Environmental
Protection Agency

Re: Hancock County
P&A Industries
Industrial
Storm Water

July 7, 2011

6/7/2011 Hancock County, P&A Industries. Material storage under overhang on the north side of the building. Taken by Lynette Hablitzel. P&A_Industries_06072011_02.jpg

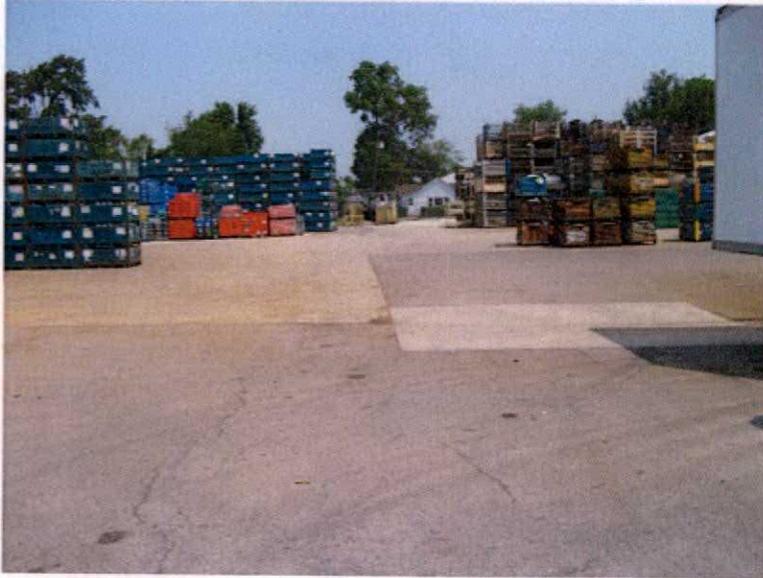
4. Industrial activities with potential exposure of pollutants to storm water include: material loading and unloading activities at the docking bay doors in the event of a spill, storage of metal parts racks, and fume collection systems. Metal scrap bins were located under an overhang on the north side of the building. Catch basins in this area are directed to the sanitary sewer.
